# Access Compliance Report

## Public Rights-of-Way

### (Curb Ramps)

Intersection ID: 30281	Main Street: BLYTHEDALE_DR	Cross Street: ELSBERRY_LN	Location: S
ADA ID: 9ACE0ACD979B	Ramp Type: PerpDiag	Initial Pass/Fail: Fail	Overall Compliance: No
Severity Score: 33.75			
Codes/Mitigation Info/Possible Solution		Field Measurements/Component Compliance

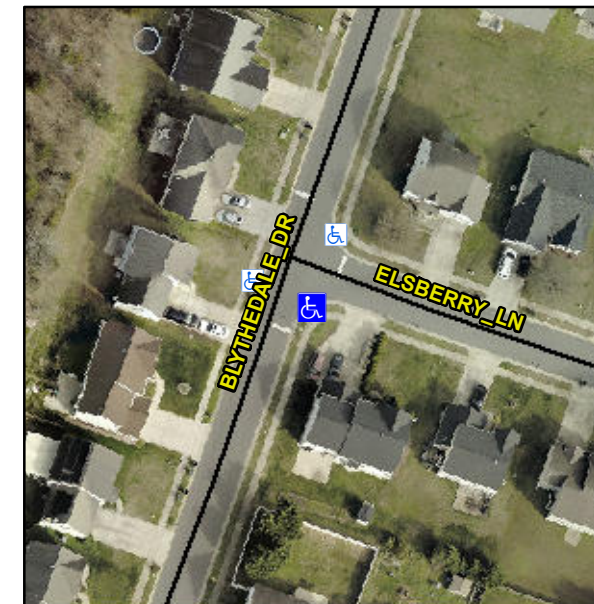
**Not Found, R304.5.1, R304.5.3**

Compliance	Description	Data	Compliance	Description	Data
N/A	Ramp Length (in)	48.0	Yes	Ramp Slope (%)	5.1
No	Ramp Width (in)	43.0	No	Ramp XSlope (%)	8.7
N/A	Flare Type LT	N/A	N/A	Flare Type RT	N/A
N/A	Flare Slope LT (%)	N/A	N/A	Flare Slope RT (%)	N/A
N/A	Flare Traversable LT?	N/A	N/A	Flare Traversable RT?	N/A
N/A	Landing Length (in)	N/A	N/A	DWS Provided?	N/A
N/A	Landing Width (in)	N/A	N/A	DWS Contrast?	N/A
N/A	Landing Slope (%)	N/A	N/A	DWS Length (in)	N/A
N/A	Landing X Slope (%)	N/A	N/A	DWS Full Width?	N/A
N/A	Landing Curb? (Y/N)	N/A	N/A	DWS Offset (in)	N/A
N/A	Shared Landing?	N/A			
N/A	Gutter Ponding?	N/A	N/A	Gutter Slope (%)	N/A
N/A	Gutter Lip Ht (in)	N/A	N/A	Gutter X Slope (%)	N/A
N/A	Painted X Walk1?	No	N/A	Painted X Walk2?	No
	X Walk 1 Direction	To E		X Walk 2 Direction	To W
N/A	X Walk 1 Width (in)	N/A	N/A	X Walk 2 Width (in)	N/A
	X Walk 1 Slope (%)	5.8		X Walk 2 Slope (%)	4.6
	X Walk 1 X Slope (%)	4.3		X Walk 2 X Slope (%)	6.1

**Remove & Replace Curb Ramp With Two New Directional Ramps or Equivalent.**
